**GEORGETOWN-SCOTT COUNTY PLANNING COMMISSION
AGENDA**

BEVINS RURAL RESIDENTIAL SUBDIVISION PLAT
Staff Report to the Georgetown-Scott County Planning Commission
August 11, 2016

CANEWOOD, UNIT 1-C, SECTION 4
Staff Report to the Georgetown-Scott County Planning Commission
October 13, 2016

GEORGETOWN CENTRE, PARCEL A
Staff Report to the Georgetown-Scott County Planning Commission
October 13, 2016

PRELIMINARY SUBDIVISION PLAT

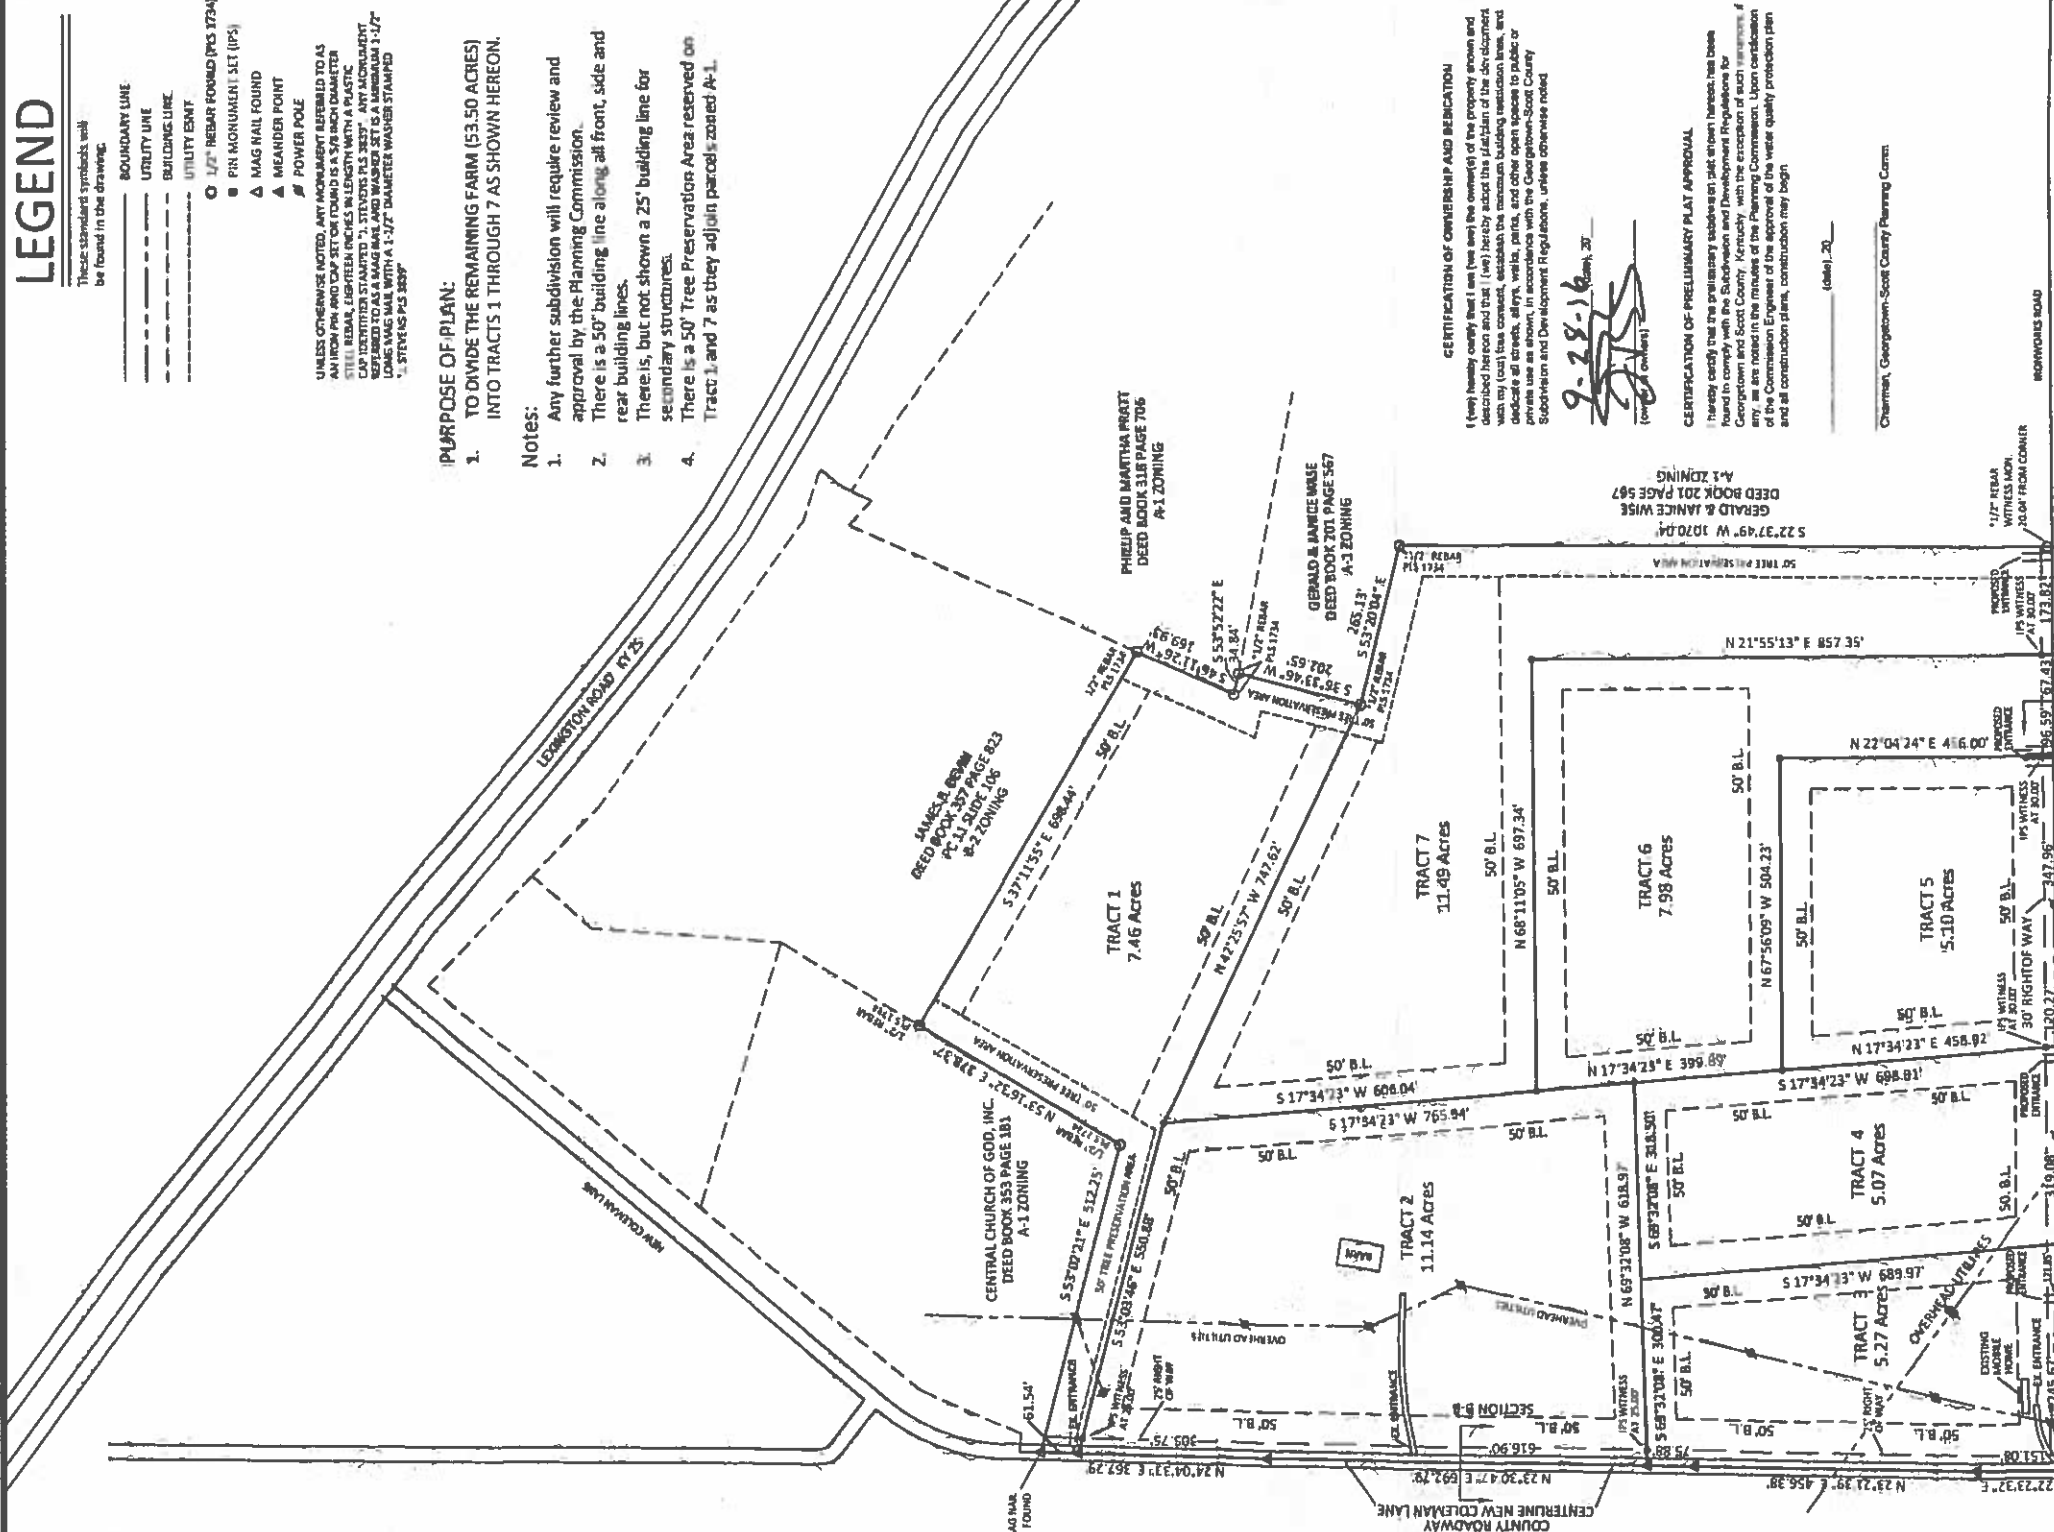
Tracts 1 and 2 will have access from New Coleman Lane via existing entrances. These two existing entrances used to serve houses on the Project Site, but these houses were removed several years ago. The existing entrance for Tract 3 is located at the intersection of New Coleman Lane and Ironworks Road. The existing entrance has been in place serving the existing mobile home for many years. The Applicant has indicated a proposed new entrance for Tract 3 from Ironworks Road. This new entrance will become the access point for Tract 3 once the existing mobile home is removed. Tracts 4 through 7 will have new entrances located on Ironworks Road.

New Coleman Lane is currently 15 feet wide along the Project Site. The County standard is for 18 feet of paved width. The Applicant will be required to widen New Coleman Lane along their frontage to 9 feet from centerline and reshape the ditch to meet county ditch profile standards. This would require an amount of site work that the Applicant feels is unjustified based on the amount of traffic impact anticipated by their subdivision. The Applicant has reconfigured the proposed subdivision to minimize the number of entrances onto New Coleman Lane. The ITE manual for single family dwelling units estimates 7 dwelling units will generate roughly 41-93 trips per weekday.

At the previous meeting, it was discussed that the existing fence along the boundary with the Wise property would suffice to meet the fencing requirement even though it does not meet the above requirements. Any new fence installed to meet the fencing requirement should meet the requirements described for the A-5 zoning district.

This preservation easement will need to be shown on the final subdivision plat. All required landscaping will need to be either installed or bonded prior to approval of the final subdivision plat.

Variance: Staff recommends **denial** of the variance to remove the requirement for improvements to New Coleman Lane.

3. All requirements of GMWSS regarding the provision of water.
4. The tree preservation easement shall be shown on the final subdivision plat.
5. All landscaping shall be either installed or bonded prior to approval of the final subdivision plat.

6. All fencing is required to be installed prior to approval of the final subdivision plat.
7. All improvements to New Coleman Lane shall be completed prior to the approval of the final subdivision plat.

GEORGETOWN CENTRE - PARCEL "A"

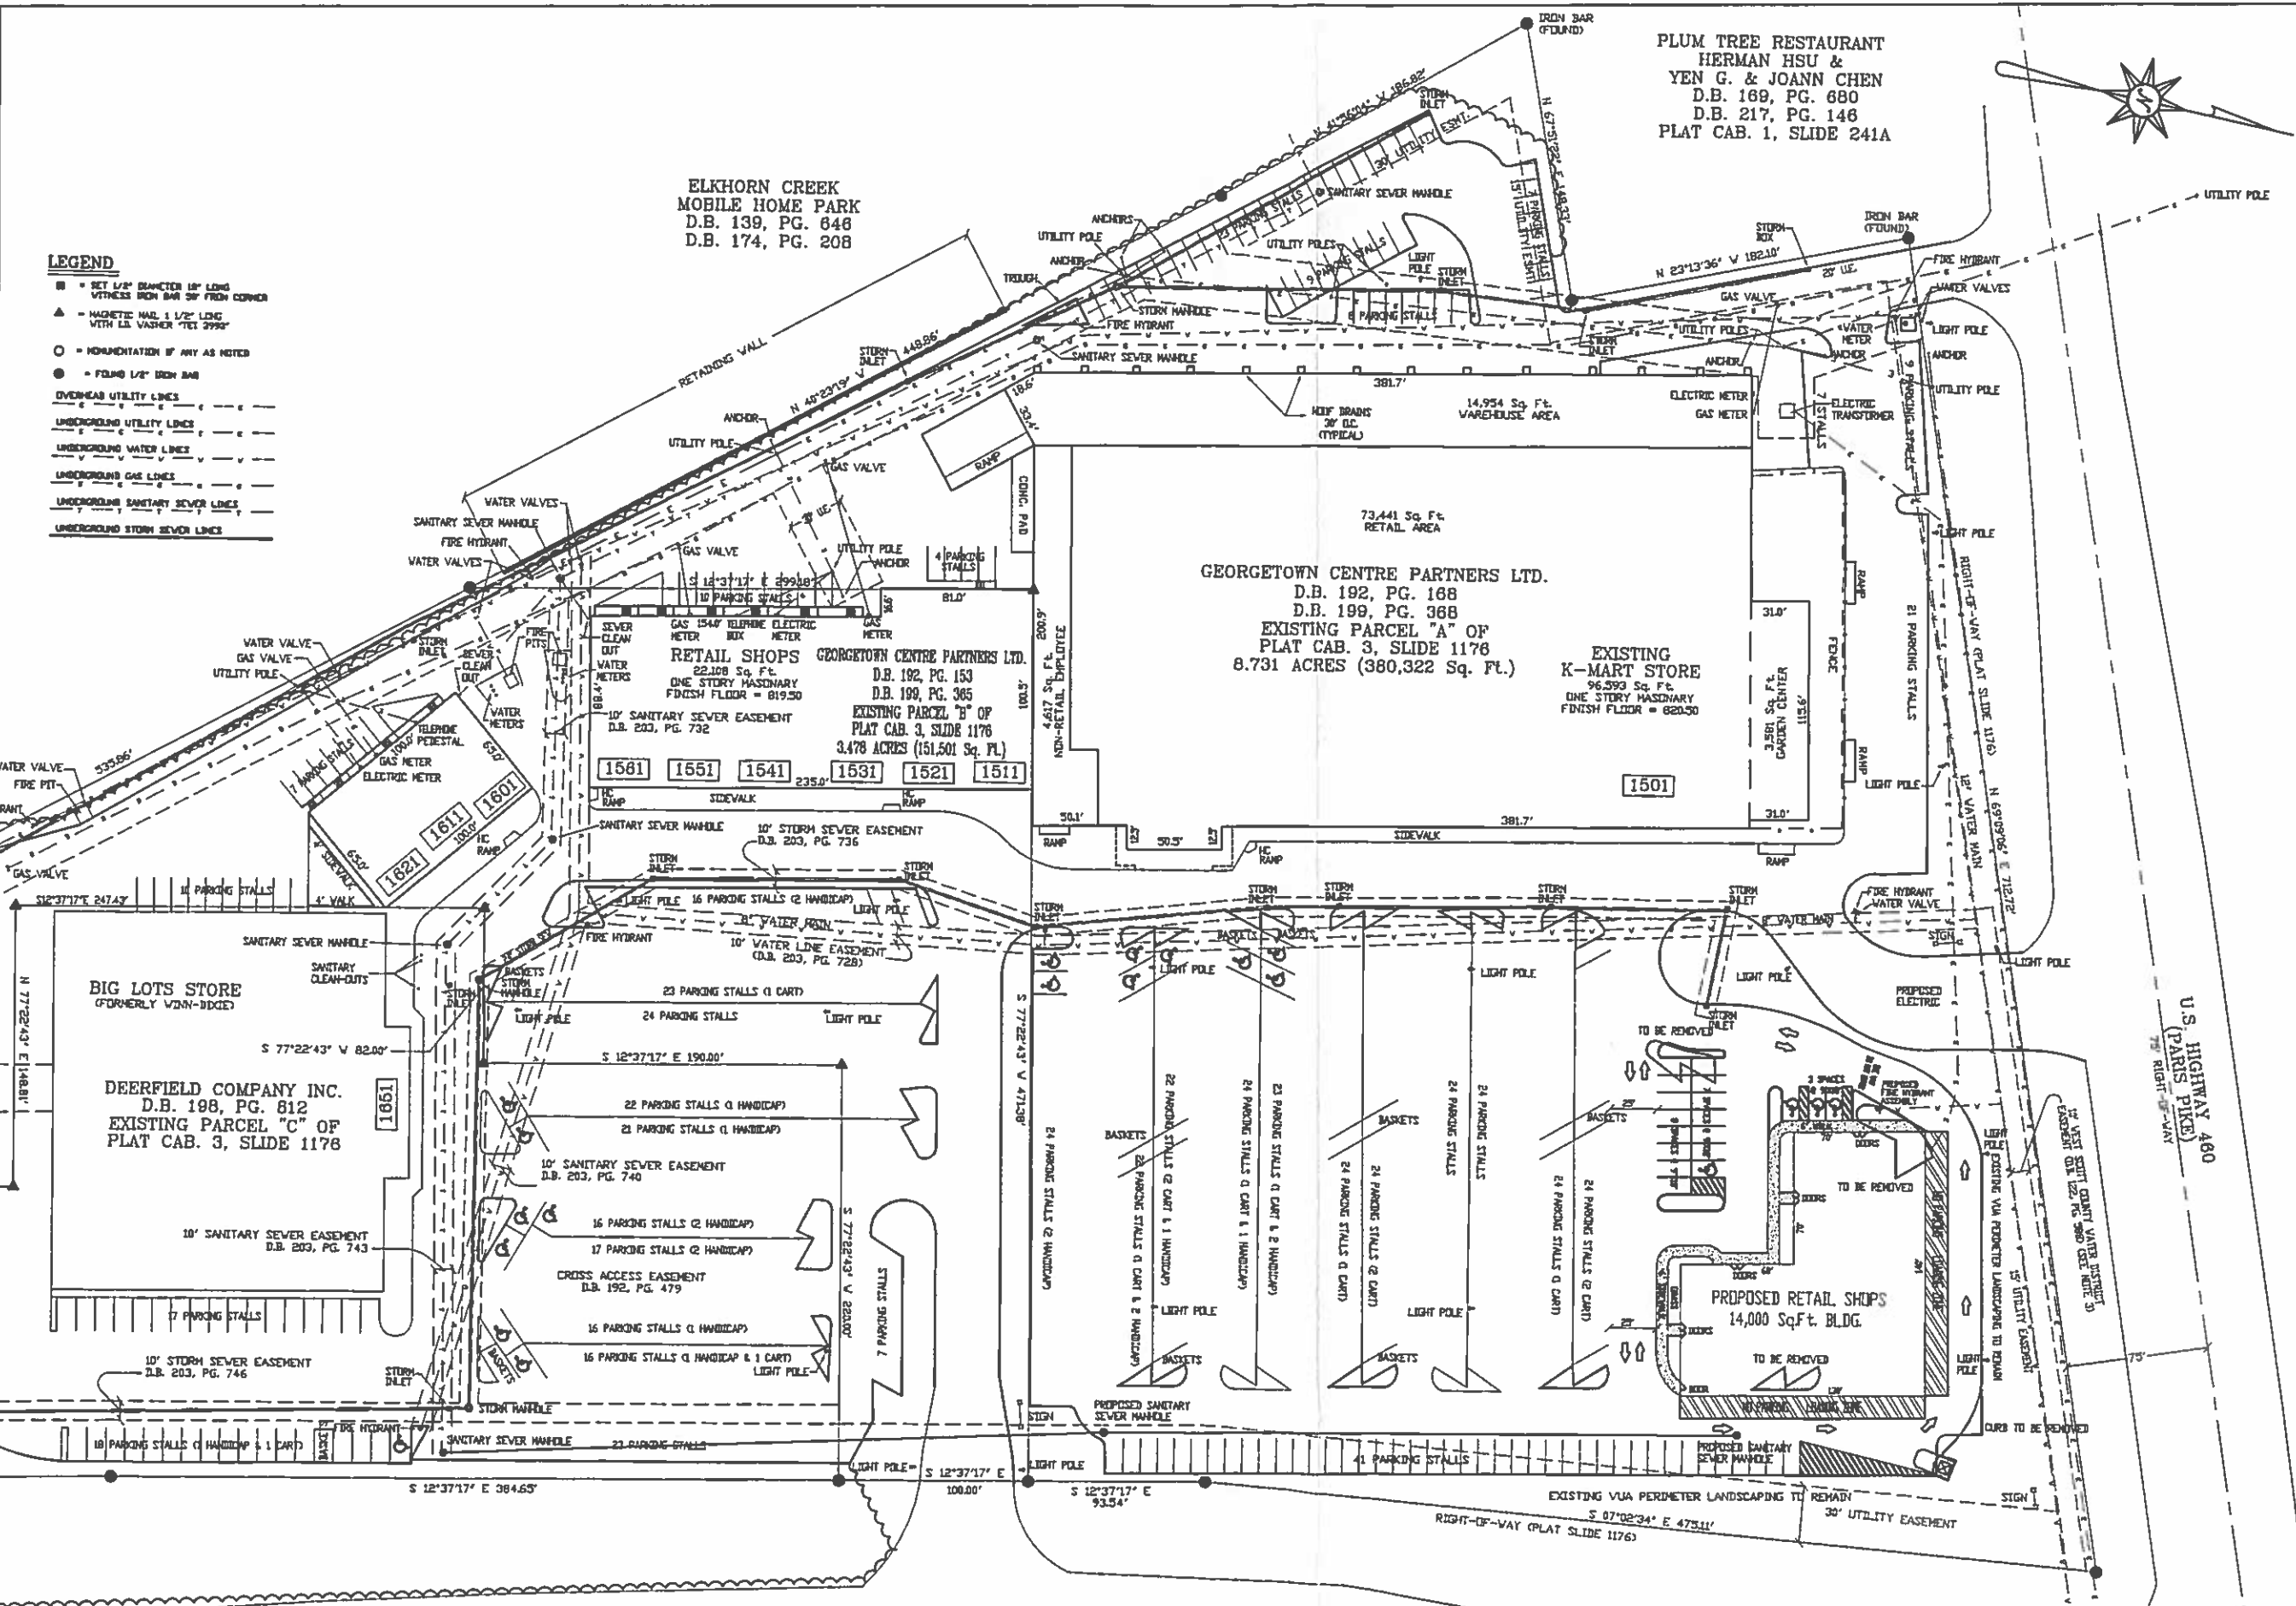
The proposed building location meets the setback requirements. The 14,000 square foot structure will increase the building area coverage 3.7% to a total of 129,128 square feet or 33.7%. This is under the 50% maximum building ground coverage allowed.

Parking Spaces: Based on the parking standard for commercial retail centers, a total of 87 spaces are required for the new building. The construction of the new building will involve tearing up a section of the existing parking lot that is currently underutilized. The drive aisles will be reconstructed around the building as well as the parking in front of the building. Ninety-nine (99) parking spaces will be removed for construction of the new building. Nineteen (19) spaces will be replaced at the front of the building, for a net loss of eighty (80) spaces. The parking count on parcel A after completion of the new building will be 418 spaces or 1 space per 265 SF of gross building area.

The proposed building placement will maintain the existing aisle width and reconstruct end islands for the parking stalls in front of the building. In the rear of the building striped loading and unloading areas are shown. It is recommended that the parking spaces to the rear of the building be diagonal to support one-way traffic and adequate back out room outside the loading zone area.

According to the applicant's calculations, the total number of parking spaces required on parcel A is 438 spaces. They are providing 418 spaces. Therefore, a variance is required to allow development of the 14,000 SF building with a reduced number of total spaces. It is recommended that the variance be approved, based on the fact that there is a shared parking agreement between the three parcels and the fact that parcel A has so much vacant and underutilized parking area.

1. Reduce the number of parking spaces required on parcel A to 418 as long as it is shown that a valid shared parking agreement is in place.

3. All parking stalls shall have the required aisle width outside any restricted loading areas.
4. No freestanding advertising signs shall be permitted for this building.
